AGENDA
PLANNING AND ZONING COMMISSION MEETING
CITY OF CREVE COEUR, MISSOURI
MONDAY, MAY 21, 2018

1. Public Hearing. #18-020: Application to Amend the Conditional Use Permit and Site Development Plan for Parking Lot Expansion and 6,421 Gallery/Building Addition for Congregation B'nai Amoona at 324 S. Mason Road

**APPLICATION TO PLANNING AND ZONING COMMISSION
#18-020 APPLICATION TO AMEND THE CONDITIONAL USE PERMIT
AND SITE DEVELOPMENT PLAN FOR PARKING LOT EXPANSION AND
6,421 GALLERY/BUILDING ADDITION FOR CONGREGATION B'NAI
AMOONA AT 324 S. MASON ROAD**

FOR THE PLANNING AND ZONING COMMISSION MEETING OF: Monday,
May 21, 2018 at 6:30 PM

Figure 1: Close-up of the Site Plan of the new Gallery and Parking Lot

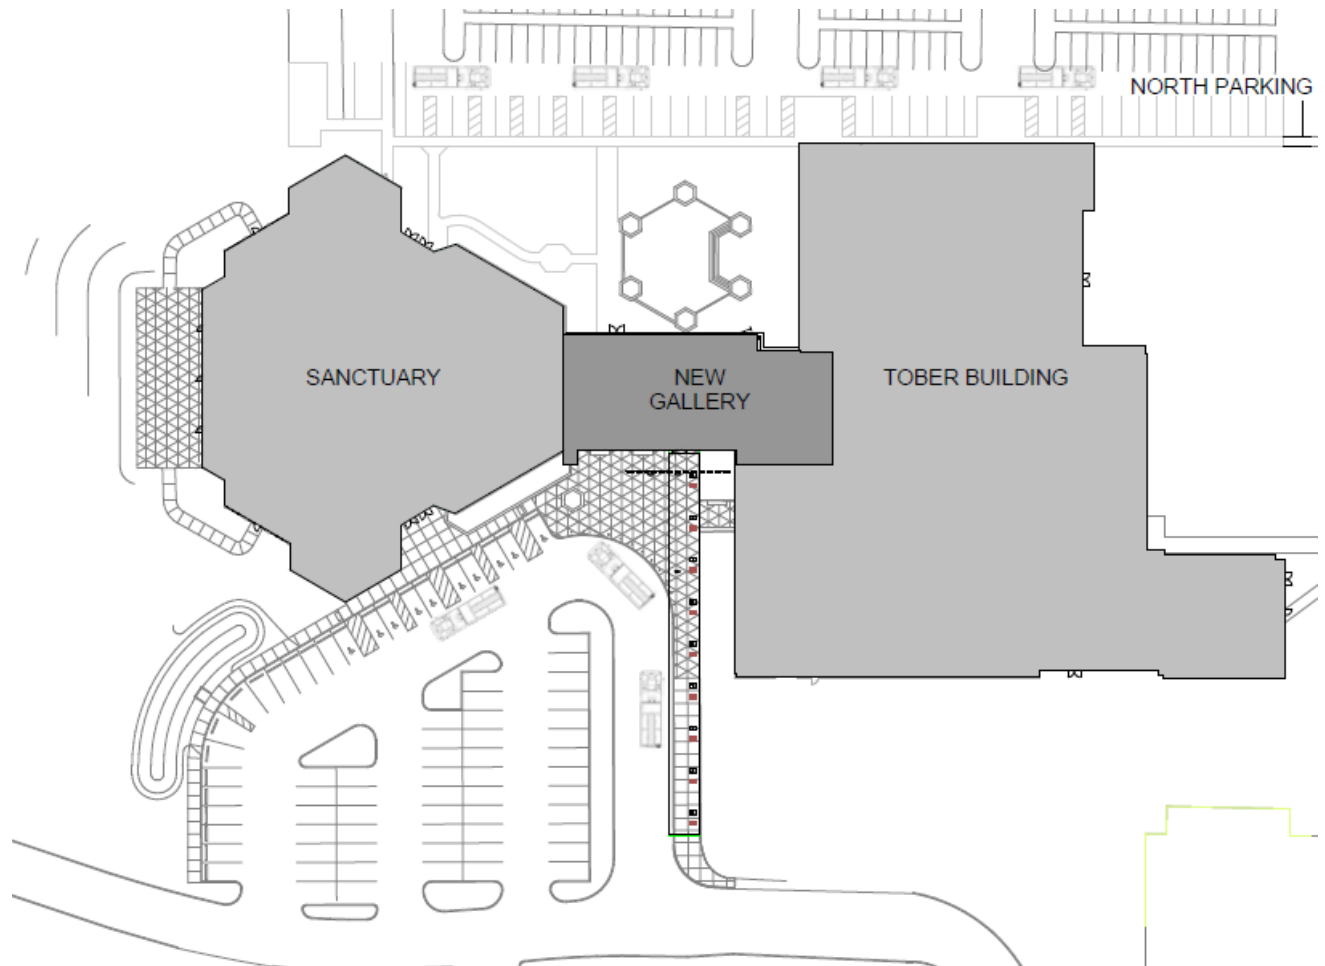
Congregation B'nai Amoona is seeking an amendment to the Conditional use permit for a new 6,421 sq. ft. gallery addition to serve as the main entrance and connecting the sanctuary and the educational building. The circular drive to the south (just north of the south parking lot) will be expanded into a parking lot for 72 new parking spaces, and new parking lot lighting. The overall site coverage will increase from 23.28% to 25.05%, or by 22,542 sq. ft. Not included in the calculations or shown on the site plan is the property addressed as 350 S. Mason that is owned by the Congregation and was included as part of the CUP in 1999. A condition of the Ordinance includes revising the site plan to include this area. Since this site is currently undeveloped, it will not increase the overall coverage, but will decrease the site coverage even further.

Figure 5: Close-up of the Tree Canopy of the Applicant's Landscape Plan

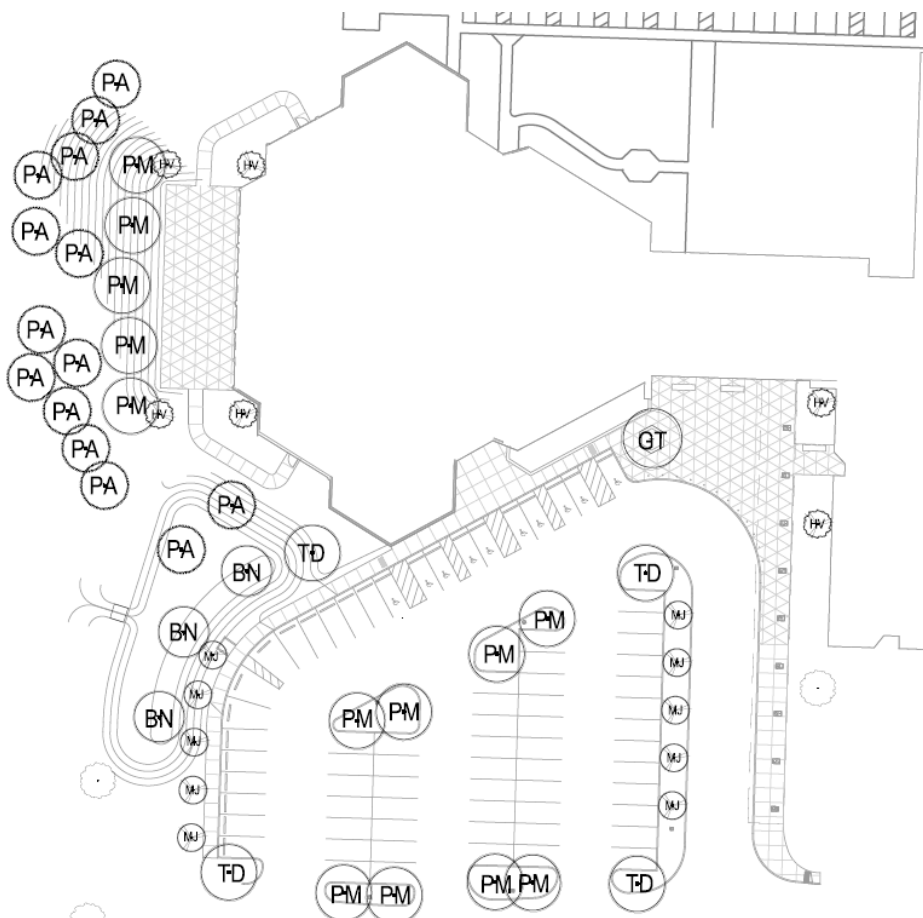
Section 405.540 Landscaping of the Zoning Ordinances requires a minimum of a minimum of 10 square feet of interior landscaping for each 350 square feet of parking spaces and driving aisles, and shall be in one or more areas to minimize the size of parking areas, and there shall be at least one shade tree for each landscaped area, and a minimum of two shade trees, within and up to, every 100 linear feet of parking for each parking row. Such trees shall be spaced evenly around the perimeter, and the ends of parking rows abutting a circulation aisle shall be defined by interior landscaped areas whenever feasible. As discussed earlier, the Design Guidelines recommend a landscaped break for every 8 to 10 parking spaces. The proposed parking layout does not comply with the recommendations of the Design Guidelines, where rows of parking stalls exceed 20 spaces in areas. However, sufficient landscaping and number of shade trees have been provided within the interior median of the new proposed area. Subsection (F)(5) of the Landscaping requirements allows for in the instance of a planned development which occupies a site in excess of three acres, which has an overall site coverage of less than 40% and which additional landscaping elsewhere on the site in compensation for that which otherwise would be located in required interior landscaped areas in parking lots, the Planning and Zoning Commission may waive the required interior landscaping. Overall the proposal includes well landscaped areas with additional trees and plantings in front of the buildings to provide greater interest along S. Mason Road.

6. A Final Landscape Plan shall be provided that includes the replacement of missing trees within the parking lot islands within the existing north and south parking lot and in substantial compliance with the Landscape plan submitted on May 11, 2018 as bound together and submitted in conjunction with Application #18-020 by HOK and with Section 405.540 Landscaping of the Zoning Ordinance.

Figure 6: Cloe-up of the Understor Plan of the Applicant's Landscape Plan.

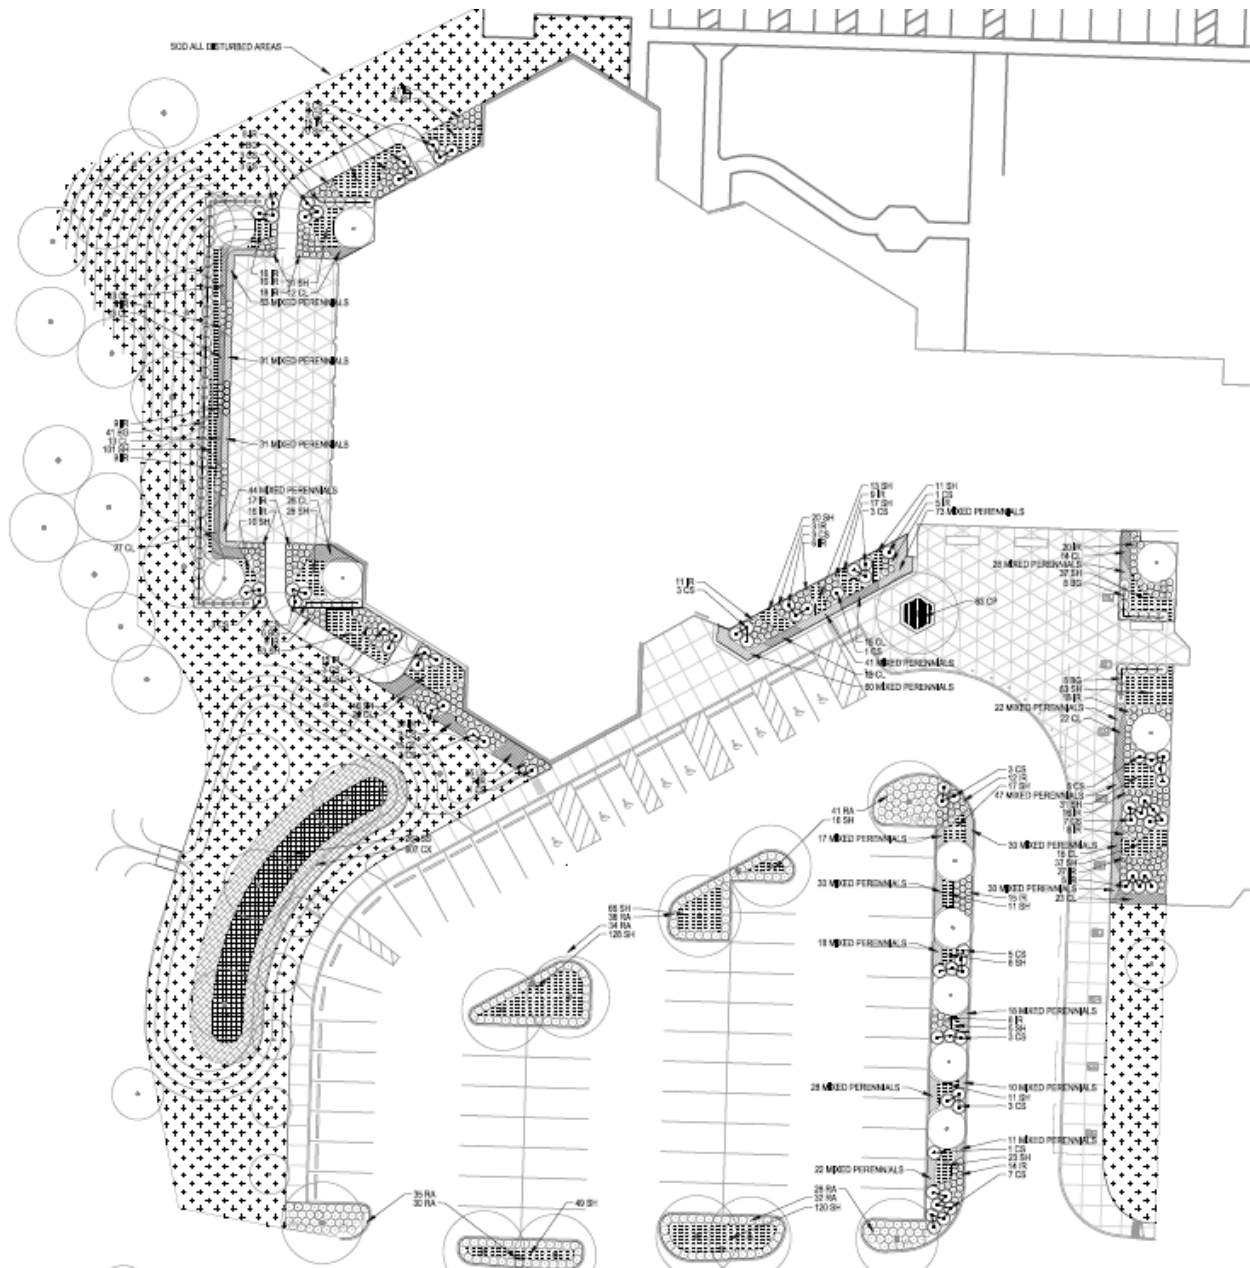
If the Commission finds that the landscaping provided meets with the intent of the Ordinance and Design Guidelines above and given that the overall site coverage is less than 40% at 25.05%, the Commission may approve the plan as proposed, or discuss including additional landscaping options with the Applicant. A Landscape Plan for the entire site was not provided, and in reviewing the plans from the original Conditional Use Permit, and the City's GIS, there appears to be missing landscaping in the existing parking lot to the south of the proposed addition. Therefore, Staff has included a condition of approval that the final landscape plan shall be submitted to include the replacement of landscaping in the parking lot islands to be in compliance with Section 405.540 Landscaping for the Zoning Administrator's approval.

SITE & GRADING PLAN

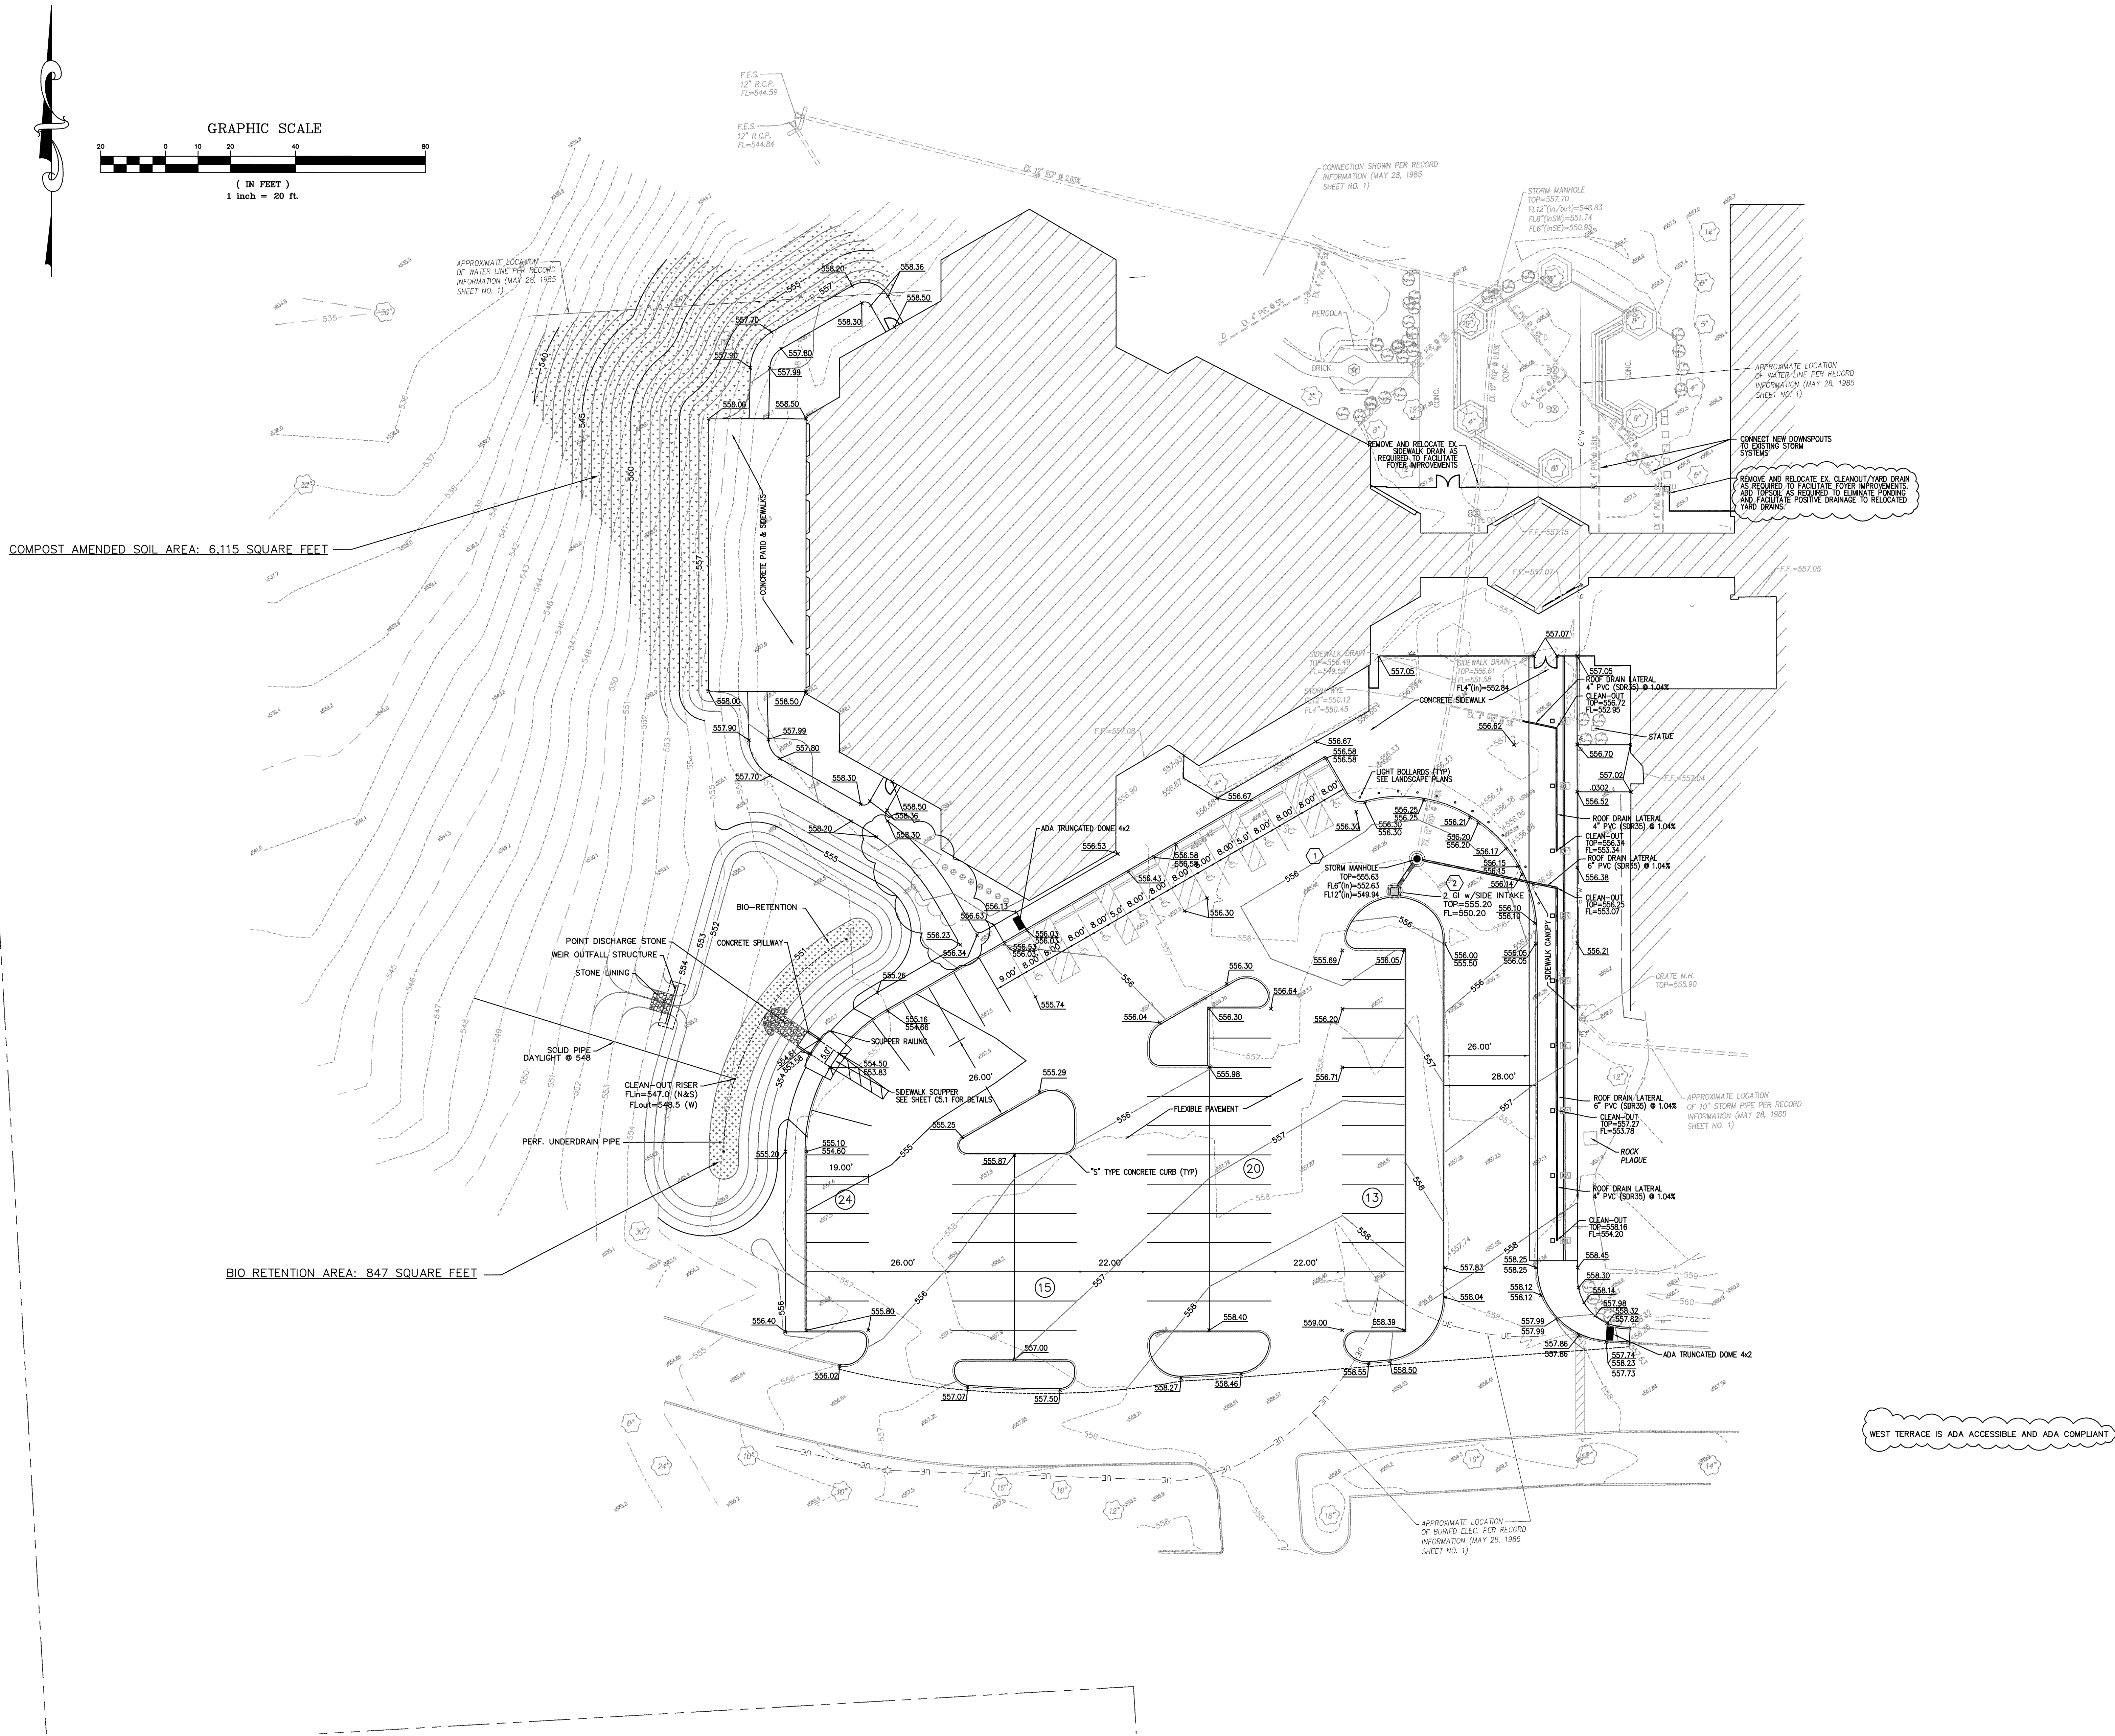
The proposal includes new 6 foot wide pedestrian connections along the west side of the new parking lot in compliance with the Design Guidelines that call for direct access from the street and parking areas to principal structure. However, the site development plan shows the sidewalk is 6 feet in width and directly adjacent to the curb. Therefore a proposed condition of approval requires that the site development plan shall be revised to provide curb stops or that the sidewalk shall be increased in width to eight feet if used as a curb stop, and that the sidewalk be extended from the new parking area to S. Mason Road as required below:

3. The Site Development Plan shall be provided to include the property of 350 S. Mason Road, and the calculations shall be revised with this new area.
4. The Site Development Plan shall be amended to extend the sidewalk from the new parking area to the existing sidewalk along S. Mason Road and all new sidewalks shall comply with Section 405.730 Sidewalks of the Zoning Ordinance.
